# AIRCRAFT ARMAMENT

# UPDATE

## ACALA PAMPHLET 750-1-2

*This information contains update and supplemental information pertaining to Aircraft Armament/Fire Control Systems, Support Equipment, and Supply Publications until a formal change or revision is published. Annotate these changes in your manuals.*

Figure C-24. Umbilical Harness Assemblies .50 cal. MG (406-075-192-107), Left Hand Jettison (406-075-192-109), Right Hand Jettison (406-75-192-111), Hellfire Missile (406-075-192-101), 2.75-Inch Rockets (406-075-192-103), and Air-to-Air Stinger (406-075-192-105)

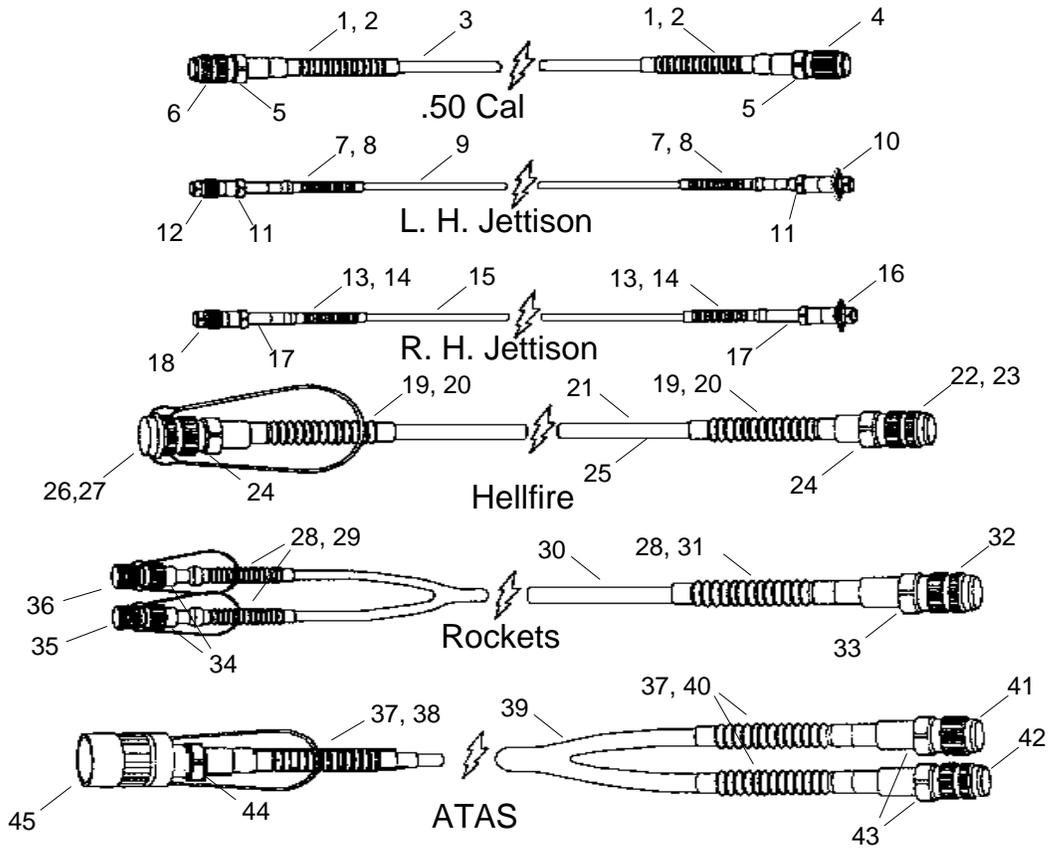
m. Pages C-24 thru C-24-3: Recent 2028s and maintenance concept changes have resulted in corrections to figure C-24 and the repair parts and special tools list. These corrections are shown below:

ITEM NO	SMR CODE	CAGEC	PART NUMBER	DESCRIPTION AND USABLE ON CODES (UOC)	QTY
GROUP 07					
Figure C-24. Umbilical Harness Assemblies .50 cal. MG (406-075-192-107), Left Hand Jettison (406-075-192-109), Right Hand Jettison (406-075-192-111), Hellfire Missile (406-075-192-101), 2.75-Inch Rockets (406-075-192-103), and Air-to-Air Stinger (406-075-192-105)					
1	PAFZZA	70847	A10099	BAND, MARKER	2
2	PAFZZA	06090	202C632-51	BOOT, VEHICULAR COM	2
3	XAFFFA	97499	406-075-633-109	CABLE ASSEMBLY	1
4	PAFZZA	81349	D38999/26WJ4SN	CONNECTOR, PLUG, ELECTRICAL (21A7P1)	1
5	PAFZZA	07418	SB01B6H2510X1	ADAPTER, CABLE CLAMP	2
6	PAFZZA	81349	D38999/26WJ4PN	CONNECTOR PLUG, ELECTRICAL (21P1)	1
7	PAFZZA	70847	A10099	BAND, MARKER	2
8	PAFZZA	06090	202C611-51	INSULATION SLEEVING (BOOT)	2
9	XAFFFA	97499	406-075-633-105	CABLE ASSEMBLY, SPECIAL	1
10	PAFZZA	96906	MS3475W10-6P	CONNECTOR PLUG, ELECTRICAL (21P3)	1
11	PAFZZA	07418	SB01A1H1004X1	ADAPTER, CABLE CLAMP	2

12	PAFZZA	96906	MS3470W10-6S	CONNECTOR, RECEPTACLE (21J5)	1
13	PAFZZA	70847	A10099	BAND, MARKER	2
14	PAFZZA	06090	202C611-51	INSULATION SLEEVING, (BOOT)	2
15	XAFFFA	97499	406-075-633-107	CABLE ASSEMBLY, SPECIAL	1
16	PAFZZA	96906	MS3475W10-6P	CONNECTOR PLUG, ELECTRICAL (21P4)	1
17	PAFZZA	07418	SB01A1H1004X1	ADAPTER, CABLE CLAMP	2
18	PAFZZA	96906	MS3470W10-6S	CONNECTOR, RECEPTACLE (21J6)	1
19	PAFZZA	70847	A10099	BAND, MARKER	2
20	PAFZZA	06090	202C642-51	BOOT, DUST AND MOISTURE	2
21	XAFFFA	97499	406-075-634-103	CABLE ASSEMBLY	1
22	PAFZZA	49367	T3W-1225-92PN	CONNECTOR PLUG, ELECTRICAL (22P6/7)	1
23	PAFZZA	81349	M39029/76-424	.CONTACT, ELECTRICAL	2
24	PAFZZA	07418	SB01B6H2516X1	ADAPTER, CABLE CLAMP	2
25	PAFZZA	97499	100-075-5W	PLATE, MARKING, BLANK	V
26	PAFZZA	81349	D38999/30WJ4LN	CONNECTOR PLUG, ELECTRICAL (24A2/3P1)	1
27	PAFZZA	81349	M39029/77-428	.CONTACT, ELECTRICAL	2
28	PAFZZA	70847	A10099	BAND, MARKER	3

29	PAFZZA	06090	202C621-51	INSULATION SLEEVING (BOOT)	2
30	XAFFFA	97499	406-075-633-111	CABLE ASSEMBLY, SPECIAL	1
31	PAFZZA	06090	202C632-51	BOOT, VEHICULAR COM	1
32	PAFZZA	49367	T3W-1225-92PN	CONNECTOR PLUG, ELECTRICAL (22P6/7)	1
33	PAFZZA	07418	SB01B6H2510X1	ADAPTER, CABLE CLAMP	1
34	PAFZZA	07418	S3367A-15060701	ADAPTER, CABLE CLAMP	2
35	PAFZZA	97499	30-039F16-26S	CONNECTOR PLUG, ELECTRICAL (21A9/10P2)	1
36	PAFZZA	97499	30-039F16-23S	CONNECTOR PLUG, ELECTRICAL (21A9/10P1)	1
37	PAFZZA	70847	A10099	BAND, MARKER	3
38	PAFZZA	06090	202C642-51	BOOT, DUST AND MOISTURE	1
39	XAFFFA	97499	406-075-632-103	CABLE ASSEMBLY, SPECIAL	1
40	PAFZZA	06090	202C632-51	BOOT, VEHICULAR COM	2
41	PAFZZA	81349	D38999/26WJ4PN	CONNECTOR PLUG, ELECTRICAL (21P1/2)	1
42	PAFZZA	49367	T3W-1225-92PN	CONNECTOR PLUG, ELECTRICAL (22P6/7)	1
43	PAFZZA	07418	SB01B6H2512X1	ADAPTER, CABLE CLAMP	2
44	PAFZZA	07418	SB01B6H2518X1	ADAPTER, CABLE CLAMP	1

45	PAFZZA	13556	CN1079WJ61BSN	CONNECTOR PLUG, ELECTRICAL (21A5/6P1)	1
